UNITED STATES PATENT AND TRADEMARK OFFICE

APPLICATION NO.	FILING DATE	FIRST NAMED INVENTOR	ATTORNEY DOCKET NO.	CONFIRMATION NO.
10/790,432	03/01/2004	Rick James Morse	D0932-00431	9791
8933	7590	03/22/2007		
DUANE MORRIS, LLP IP DEPARTMENT 30 SOUTH 17TH STREET PHILADELPHIA, PA 19103-4196			EXAMINER KENNY, DANIEL J	
			ART UNIT	PAPER NUMBER
			3635

Office Action Summary

DETAILED ACTION

Annotated Fig. 1 (U.S. Pat. 5,916,095)

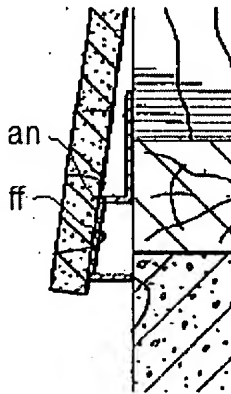
Claims 1, 2, 4, and 5 are rejected under 35 U.S.C. 102(b) as being anticipated by Tamlyn (5,916,095).

Tamlyn discloses a (note: The product by process limitation, extruded, does not structurally define over the reference as applied to the claims because the reference article is made of plastic) plastic (col. 4, line 12) starter strip (20) comprising:

a fastener flange (28);

a siding support element (32) connected (connected via 30) to the flange,

wherein the support element has a front face (ff);

a spacer element (30) connected to the siding support element, wherein the spacer includes an angle component (an) wherein the front face and the angle component are inclined at an equal 3° angle ($\tan^{-1} \frac{1}{2}/8 = 3^\circ$, col. 4, lines 39-45) away from vertical; and

a flashing element (34) connected to the spacer element.

Annotated Fig. 3 (U.S. Pat. 4,034,012)

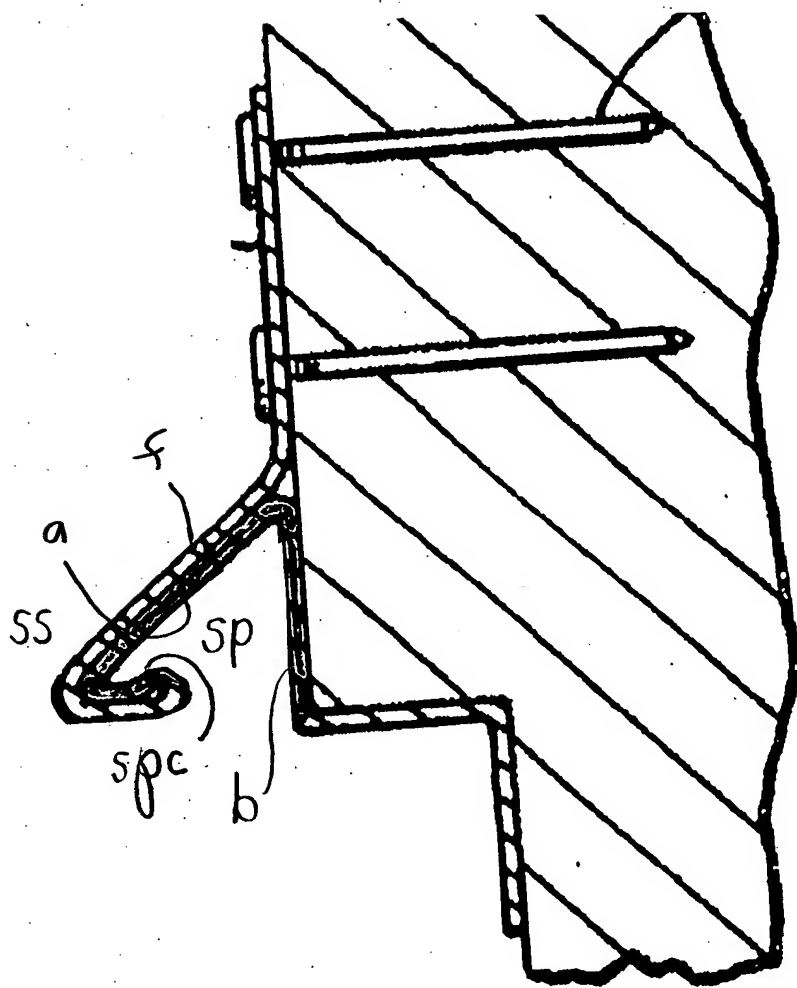
Claims 1, 3, 4, and 10-12 are rejected under 35 U.S.C. 102(b) as being anticipated by Paradisi et al. (4,054,012).

Paradisi discloses a folded metal (col. 2, line 35) starter strip (14) comprising:

a fastener flange (18);

a siding support element (ss) connected to the flange, wherein the support element has a front face (f);

a spacer element (sp, see darkened portion shown at annotated Fig. 3 directly below) connected to the siding support element, wherein the spacer includes an angle component (a) wherein the front face and the angle component are inclined at an equal angle away from vertical; and

a flashing element (38, 40) connected to the spacer element, wherein the flashing element includes a horizontal (38) member wherein an end extends beyond the plane of fastening flange and an end terminates at a point even with the plane of the fastening flange, and a vertical (40) member.

the spacer element including a spacing component (spc) connected to the siding support element;

an angle component (a) connected to the spacing component, and;

a bottom component (b) connected to the angle component.

Annotated Fig. 3 (U.S. Pat. 4,054,012)

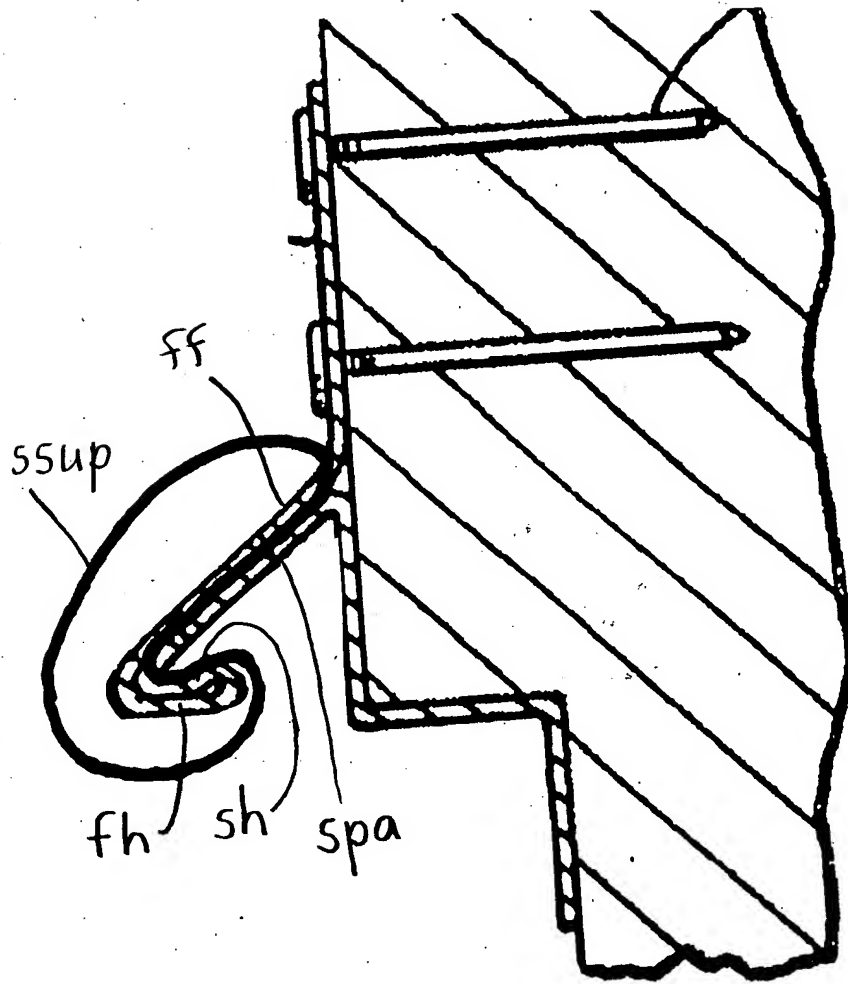
Claims 1, 3, and 6 are rejected under 35 U.S.C. 102(b) as being anticipated by Paradisi et al.

Paradisi discloses a folded metal (col. 2, line 35) starter strip (14) comprising:

a fastener flange (18);

a siding support element (ssup, see annotated Fig. 3 below) connected to the flange, wherein the support element further includes a first (fh) and second (sh) horizontal member which are substantially perpendicular to the fastener flange;

a spacer element (spa) connected to the siding support element; and

a flashing element (20) connected to the spacer element.
